### Washington Public Power Supply System

Subject : NUCLEAR PROJECT 2  
NRC INSPECTION REPORT 50-397/83-38 NOTICE OF VIOLATION

Attachment 1 is a response to NRC Inspection Item 83-38/02, Quality Class I - As-Built Program, provided to the Resident Inspector at WNP-2.

Attachment 2 contains representative calculations, including some worst case conditions, performed by Stone and Webster during their performance of a third-party assessment of QCI and QCII/Seismic I as-builts for WNP-2.

REF DOC PCN	N/A	RFI	N/A	WPPSS NUCLEAR PROJECT NO. 2	
REF SPEC SECTION	15A	PAGE	15A-222	PARA	ATTACH. 10
REF DWG	N/A	DWG ZONE		PED 215-H-WBS1	SHT 11 OF 22
SCALE	N/A	DRAWN BY	EE	DATE	7/2/83
		CHKD	1/TB	DATE	7/1/83
		APPROV	EE	DATE	7/1/83
				TITLE	AS-BUILT
				SPECIFICATION	REVISION

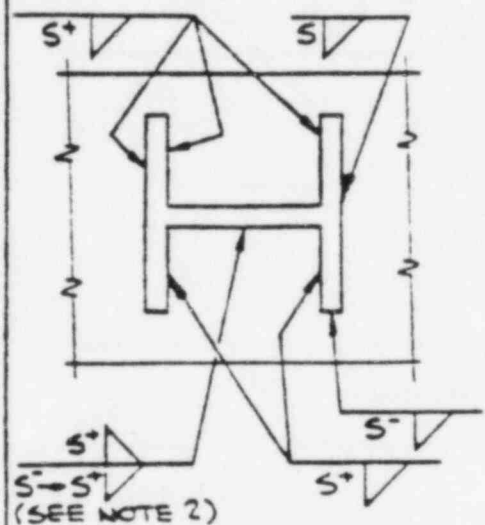
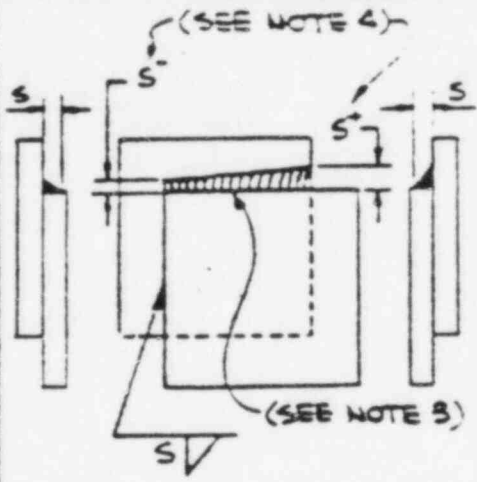
The as-built representation of welds on the Support Detail Sheets shall meet the requirements of ATTACHMENT 10 entitled, "APPROVED METHOD FOR THE AS-BUILT REPRESENTATION OF COMPLEX WELDS" of this Specification Section.

REF DOC PCN	RFI	WPPSS NUCLEAR PROJECT NO. 2	
REF SPEC SECTION	PAGE	BURNS AND ROE, INC.	
REF DWG	DWG ZONE	PED 215-H-W941	SHT 3 OF 3
SCALE	DRAWN BY	DATE	TITLE
	WTM	7/27/83	DWG. H-501, SH 1, DETAIL 22
CHKD BY	DATE	APPRD	DATE
	7-27-83	GEE	7/29/83

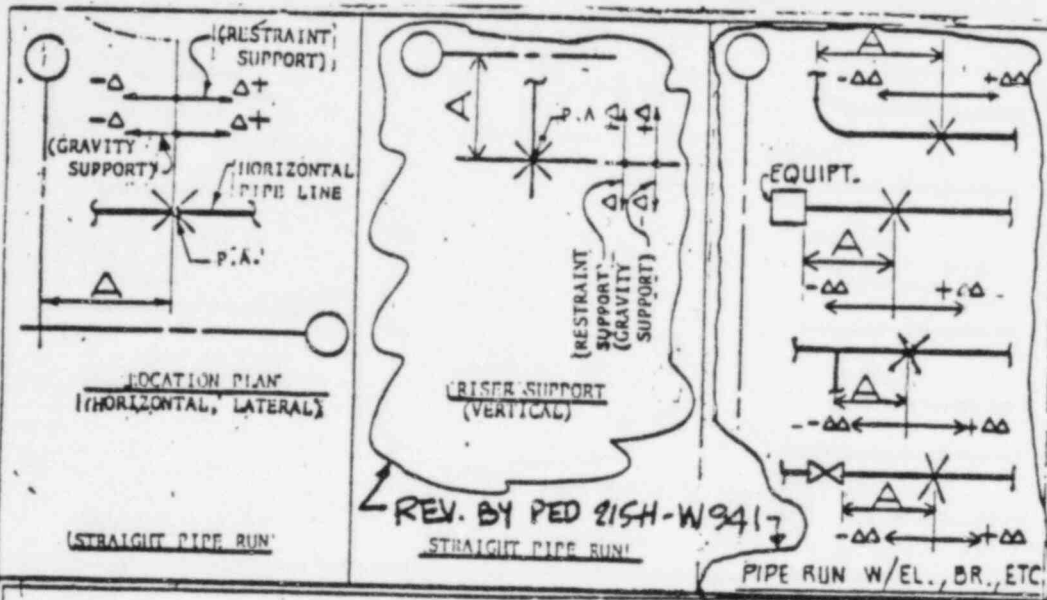
REVISE CONTRACT DRAWING H-501 AS SHOWN  
 ON SH 3 OF THIS PED.

TABLE 22 RELOCATION TOLERANCES OF P. A. ( $\Delta$ ,  $\Delta\Delta$ )

DETAIL #13 TOLERANCE FOR MISALIGNMENT OF P. A. & S.A. FOR ROD HANGERS OR SPRING HGRS.

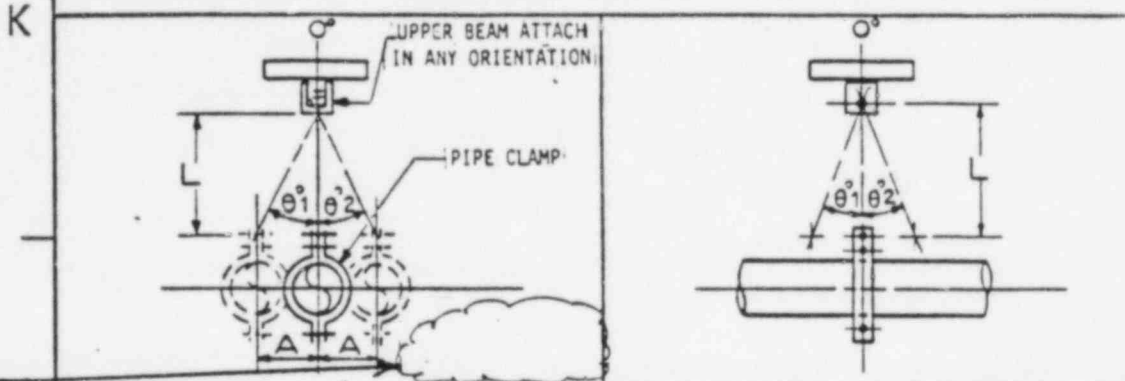
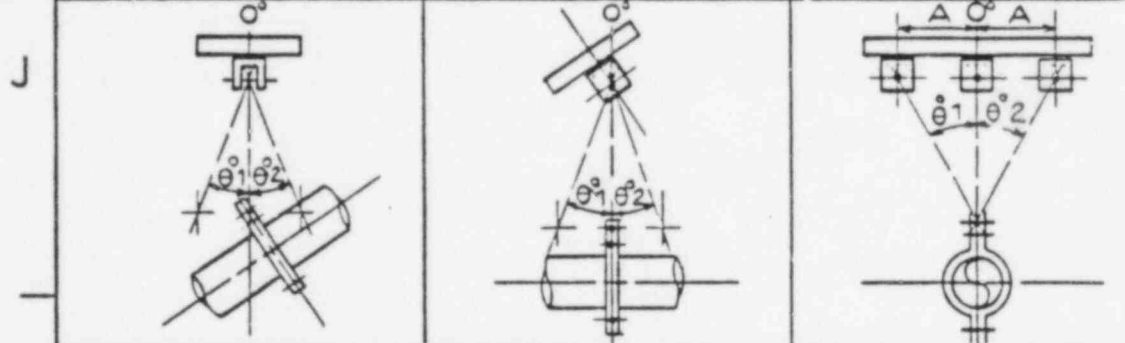
REVISE DWG. H-501 AS SHOWN ON  
SHEETS 3 THRU 16 OF THIS PED.

$A=L \cdot \tan \theta$  ( $\theta = \theta_1$  OR  $\theta_2$ ). TABLE 1 TOLERANCE FOR ANGULARITY OF ROD HANGERS OR SPRING HGRS.

ATTACHMENT 'I' SWEC ENG.  
REVIEW CHECKLIST  
HANGER COND-591

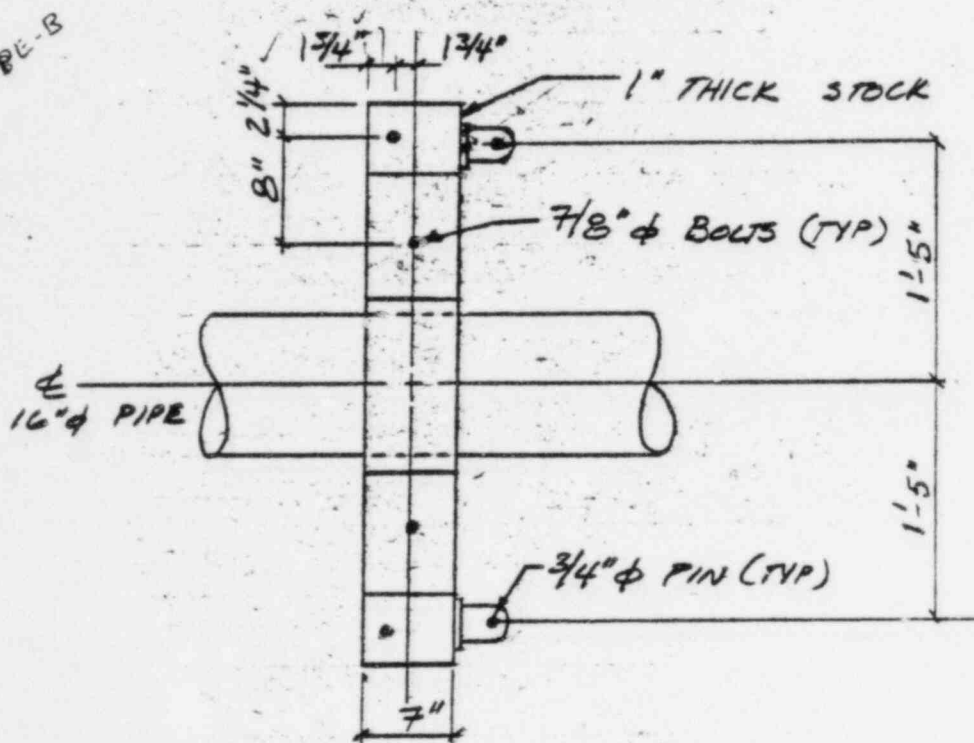
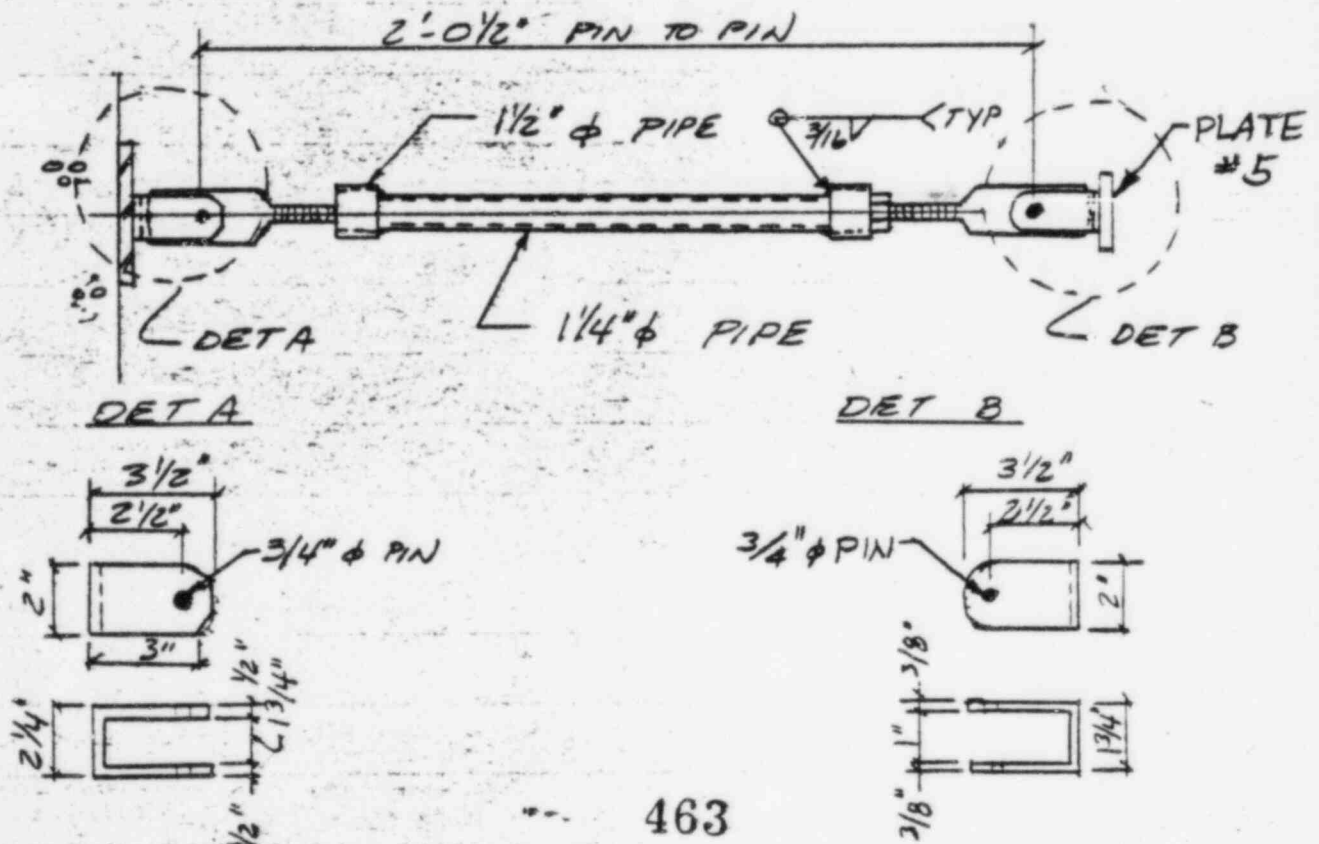
The 16"  $\phi$  riser clamp stock size called out on the as-built drawing does not agree with the clamp stock size measured. The as-built calls for a 16"  $\phi$  Special Riser Clamp Fig. 135A Stock Size = 1 1/4" x 7" w/ 1 1/4"  $\phi$  BOLTS. The clamp dimensions measured in the field are shown below:

The strut size is called out on the as-built drawing as, Rigid Strut Assembly NPS Fig. SRS Size 10 x 10 1/4" Lg., Pin  $\phi = 3/4"$ , Pipe  $\phi = 1 1/2"$  Nom., 1"  $\phi$  Rod End w/ Power Piping Size 1 1/2" HS-142 Beam Attachment. The strut measured in the field does not agree w/ this description & is shown below:

DEV.-1 THE .16"  $\phi$  RISER CLAMP STOCK SIZE CALLED OUT ON THE AS-BUILT DRAWING DOES NOT AGREE WITH THE CLAMP STOCK SIZE MEASURED. HOWEVER, THE SPECIAL CLAMP FIG-135A SPECIFIED ON THE AS-BUILT DWG. IS IN AGREEMENT WITH THE CLAMP STOCK SIZE MEASURED IN THE FIELD. (1" X 7") THE BAR STOCK SIZE ON THE AS-BUILT RESTRAINT DWG. SHOULD BE DELETED SINCE IT IS NOT CORRECT. THE BOLT SIZE CORRESPONDING TO THE BAR STOCK SIZE (1" X 7") IS 1/8"  $\phi$  BOLTS. THE SIZE BOLTS MEASURED IN THE FIELD ARE 3/4"  $\phi$ .

EVALUATION OF SUPPORT NO. SGT-901N REV. 1FO  
 ISOMETRIC NO. SGT-62.3-4.7 REV. 9FO

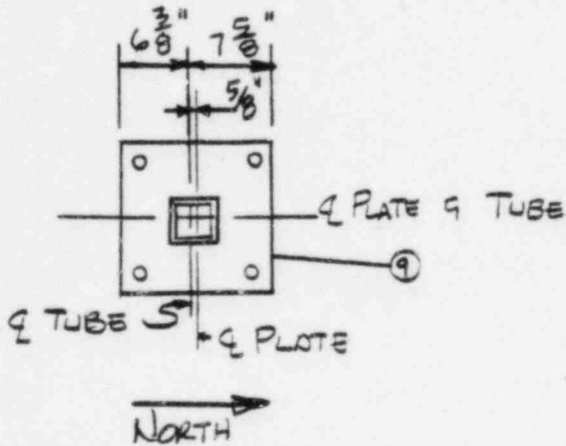
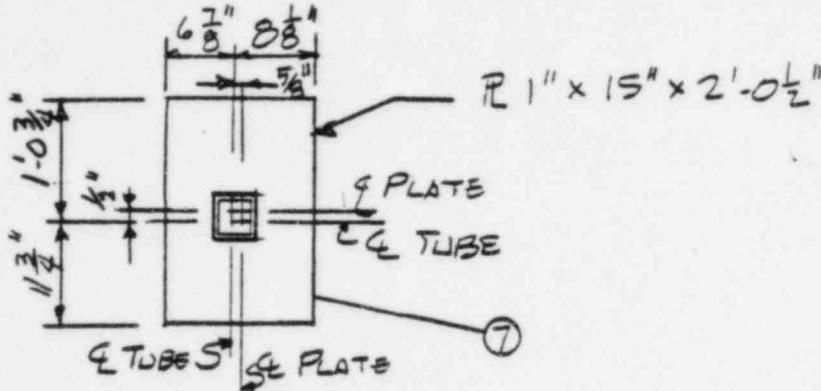
PLATE ⑨ ATTACHMENT DEVIATIONS WERE PREVIOUSLY ACCEPTED PER H-501 WHICH ALLOWS ECCENTRICITY UP TO 1"

SWEC ALLOWANCES ARE  $\pm 1/4$ "
